# SERVICE BULLETIN

## NO. A2764-71-1

POWER PLANT - FAN COWLING - HOLD OPEN ROD  
REPLACEMENT OF ROD END BEARING

FIGURE 1 - A2764-3 STRUT ASSEMBLY  
EXPLODED VIEW

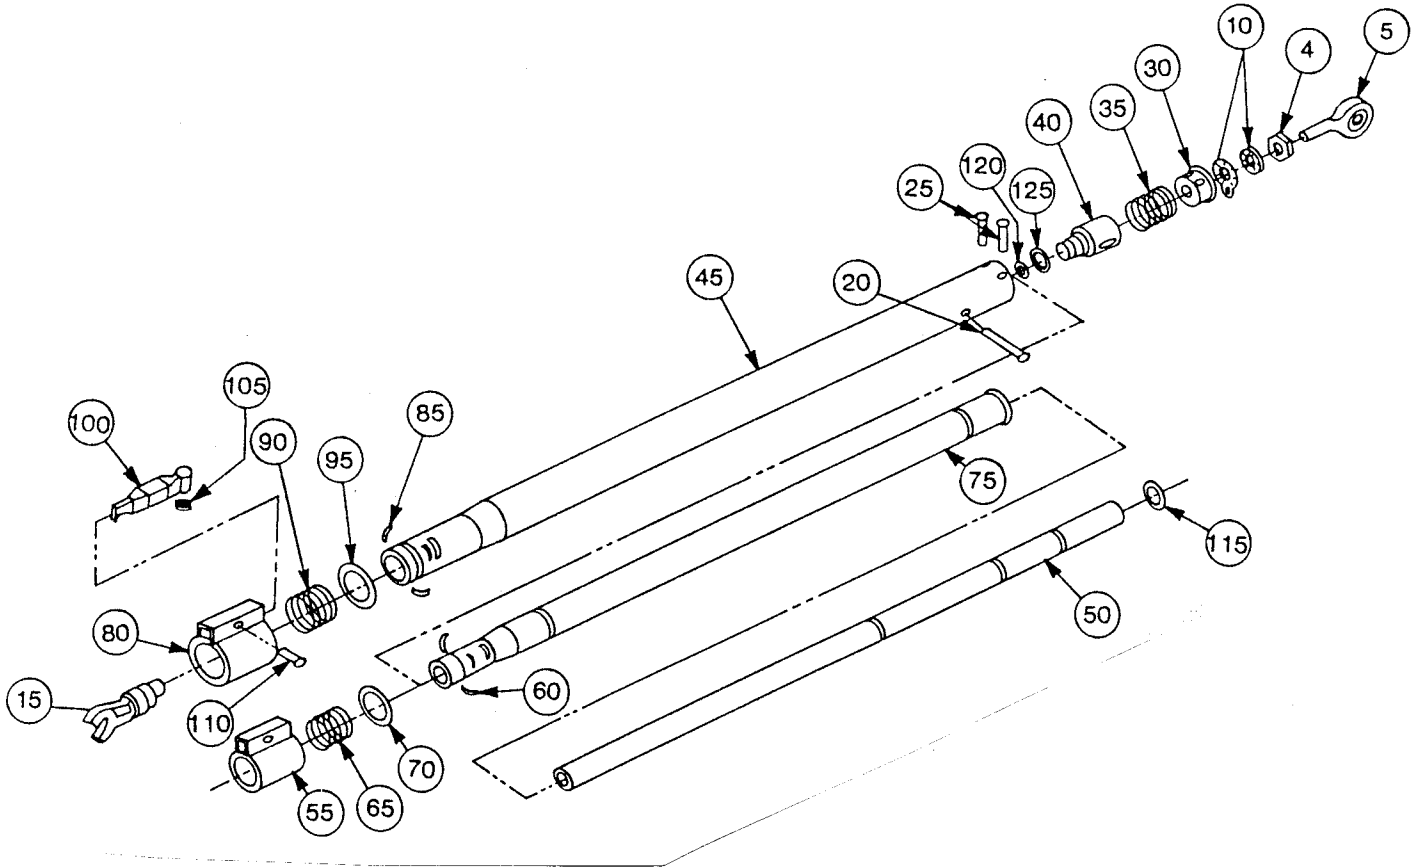
The incorporation of this Service Bulletin will replace the rod end bearing with a stronger one having a larger diameter bolt shank and make this hold open rod equivalent to the new S314T220-16 rod.

This Service Bulletin is to inform all users of the procedures and the detailed instructions required for reworking Norco strut assembly A2764-3 to make it equivalent to S314T220-16. The rework requires replacing the rod end bearing and outer tube.

### A. Disassembly (See Figure 1)

- (1) Loosen nut (4) on rod end bearing (5) by rotating counterclockwise.
- (2) Remove rod end bearing (5) by rotating counterclockwise. Locking device (10) will come off with rod end bearing (5).
- (3) Remove couplex lock assembly (15) by unthreading in a counterclockwise direction from the inner tube (50). Apply heat (350°F) to loosen thread adhesive.

- (4) Using a 5/32 inch (4 mm) diameter drill, remove rivet (20) by drilling off head and driving out remainder of rivet.
- (5) Using a 3/16 inch (4.75 mm) diameter drill, remove rivet (25) 2 places by drilling off head and driving out remainder of rivet.

- (6) Remove end fitting (30), compression spring (35) and damper (40) from outer tube (45).
- (7) Remove inner tube (50) from assembly by sliding out the back of the outer tube (45) [rod end bearing side]. When inner tube (50) is removed the lock collar assembly (55), locking dogs (60), compression spring (65) and washer (70) will also become free and can be removed from the front of the intermediate tube (75).

- (8) Remove intermediate tube (75) from assembly by sliding out the back of the outer tube (45) [rod end bearing side]. When intermediate tube (75) is removed, the lock collar assembly (80), locking dogs (85), compression spring (90) and washer (95) will also become free and can be removed from the front of the outer tube (45).

B. Assembly (See Figure 1)

- (1) Replace outer tube (45) with new outer tube, part number AM2764-16-2.
- (2) Two dowels or metal rods are required for use as assembly tools. These should be 4.5 inches (114.3 mm) long and the following diameter:

- (5) Screw couplex (15) into end of inner tube (50). Torque couplex (15) to 35 ft. lbs. Stake 4 places 90° apart at a distance of 0.25 inches from the face of the inner tube (50). Staking tool should produce an indentation, 0.060 by 0.20 inches.

- (6) Install damper into outer tube (45) "O" ring end first and align slot in damper (40) with hole in outer tube (45). Place rivet (20) through hole in outer tube (45) and slot in damper (40). Form head on rivet (20), part number MS20470-AD5-24, to retain in place.

- (8) Insert compression spring (35) and end fitting (30) into outer tube (45). Insert the 2 rivets (25), Part number AM1233-9-15, through outer tube and end fitting so that an approximate equal length protrudes on each side of the outer tube. Form heads on rivet using a riveting tool.

- (9) Install lock nut (4), part number AN316C8R, locking device (10), part number 108CO500-01, and lock washer, part number NAS513-8, on rod end bearing (5), part number 26CO313-10. Screw rod end bearing (5) into end fitting (30).

- (10) Set strut to its fully extended and locked position. Using a premeasured appropriately marked rod standard, adjust rod end bearing to obtain overall length of  $72.81 \pm .03$  inches. Length is measured from center of couplex (15) opening to center of rod end bearing (5) bore. Tighten lock nut (40).
